SUNDRY NOTICES AND REPORTS ON WELLS (DO NOT USE THIS FORM FOR PROPOSALS TO DRILL OR TO DEEPEN OR PLUG BACK TO A DIFFERENT RESERVOIR. USE "APPLICATION FOR PERMIT" (FORM C-101) FOR SUCH PROPOSALS.)		WELL API NO. 30-025-48504

2. Name of Operator Devon Energy Production Co. LP		6. State Oil & Gas Lease No.
3. Address of Operator 333 W. Sheridan Ave OKC, OK 73102		7. Lease Name or Unit Agreement Name PARSELTONGUE 15 10 STATE COM

4. Well Location Unit Letter <u>N</u> : <u>480</u> feet from the <u>South</u> line and <u>1344</u> feet from the <u>West</u> line Section <u>15</u> Township <u>23S</u> Range <u>33E</u> NMPM <u>Lea</u> County		8. Well Number <u>21H</u>

Devon Energy respectfully requests approval for optional surface casing/drilling plan of 10-3/4" surface casing inside of 13-1/2" surface hole at previously permitted set depth. Devon Energy Production Company, LP. will circulate class C cement to surface behind the 10-3/4" casing. Please see revised drill plan. Devon is also requesting a break test variance. The variance request and chart are attached.

Variance Request

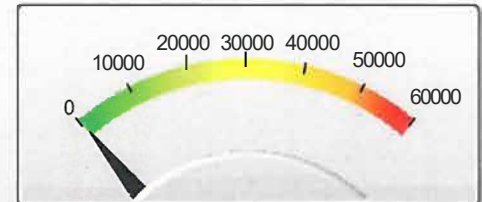
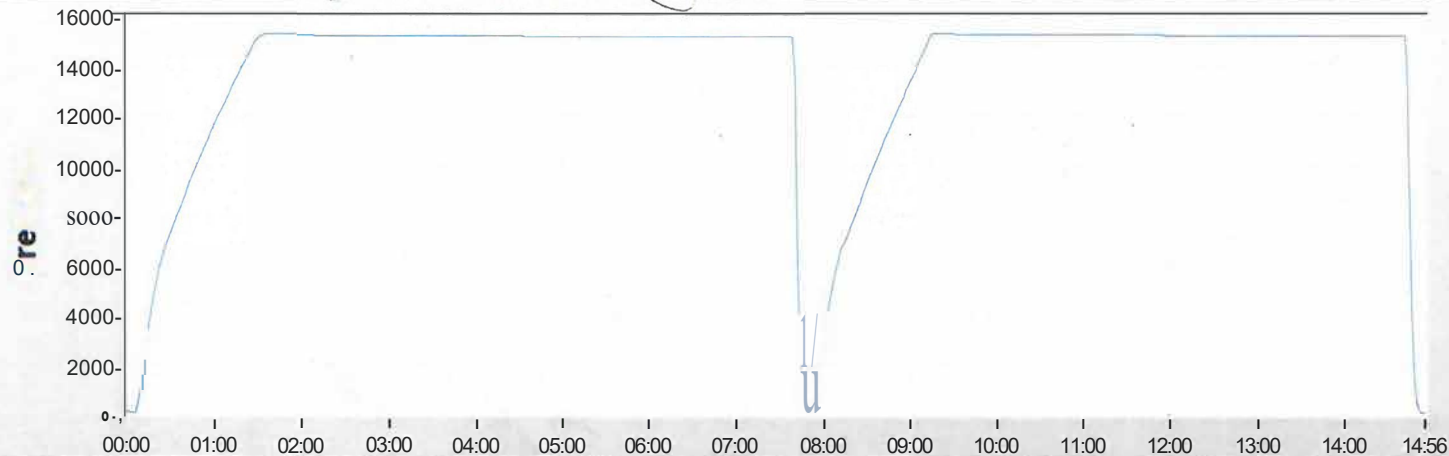
Devon Energy requests to only test BOP connection breaks after drilling out of surface casing and while skidding between wells which conforms to API Standard 53 and industry standards. This test will include the Top Pipe Rams, HCR, Kill Line Check Valve, QDC (quick disconnect to wellhead) and Shell of the 10M BOPE to 5M for 10 minutes. If a break to the flex hose that runs to the choke manifold is required due to repositioning from a skid, the HCR will remain open during the shell test to include that additional break. The variance only pertains to intermediate hole-sections and no deeper than the Bone Springs Formation where 5M BOP tests are required. The initial BOP test will follow OOGO2.III.A.2.i, and subsequent tests following a skid will only test connections that are broken. The annular preventer will be tested to 100% working pressure. This variance will meet or exceed OOGO2.III.A.2.i per the following: Devon Energy will perform a full BOP test per OOGO2.III.A.2.i before drilling out of the intermediate casing string(s) and starting the production hole, before starting any hole section that requires a 10M test, before the expiration of the allotted 14-days for 5M intermediate batch drilling or when the drilling rig is fully mobilized to a new well pad, whichever is sooner. We will utilize a 200' TVD tolerance between intermediate shoes as the cutoff for a full BOP test. The BLM will be contacted 4hrs prior to a BOPE test. The BLM will be notified if and when a well control event is encountered. Break test will be a 14 day interval and not a 30 day full BOPE test interval. If in the event break testing is not utilized, then a full BOPE test would be conducted.

1. Well Control Response:
 1. Primary barrier remains fluid
 2. In the event of an influx due to being underbalanced and after a realized gain or flow, the order of closing BOPE is as follows:
 - a) Annular first
 - b) If annular were to not hold, Upper pipe rams second (which were tested on the skid BOP test)
 - c) If the Upper Pipe Rams were to not hold, Lower Pipe Rams would be third
